Rezoning Transportation Analysis

Petition Number: 2020-025

Date	Description
02-15-2020	First Review
03-25-2020	Second Review

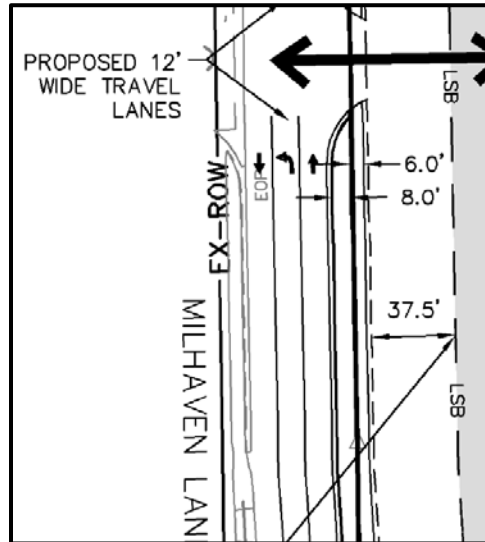
- ~~1. Millhaven Lane is an existing collector road and should provide the typical for a collector road. The petitioner should revise the site plan and conditional note(s) to place the curb and gutter along Millhaven Lane at a consistent 3-lane section (see below) across the property frontage without tapering the curb and gutter.~~

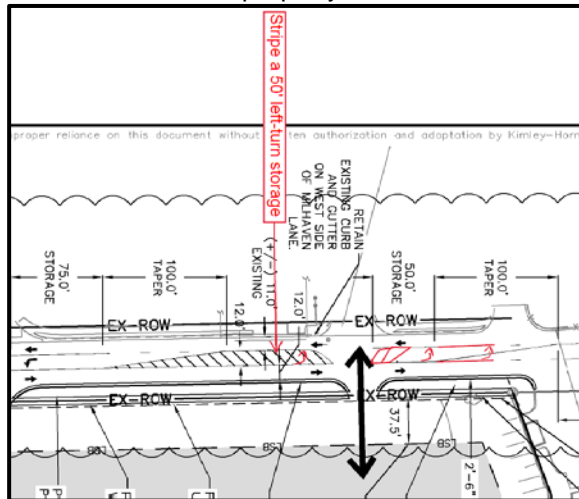
5. Technical Correction: The petitioner should revise the site plan and conditional note(s) to remove the northern driveway on Millhaven Lane or restrict access to exit only to avoid conflict points with the access across the street.
 - a. **Technical Correction Based on Revised Site Plan** The petitioner should revise the site plan and conditional notes to restripe Millhaven Lane as shown on the exhibit below, in order to keep the proposed full access near the norther property line.
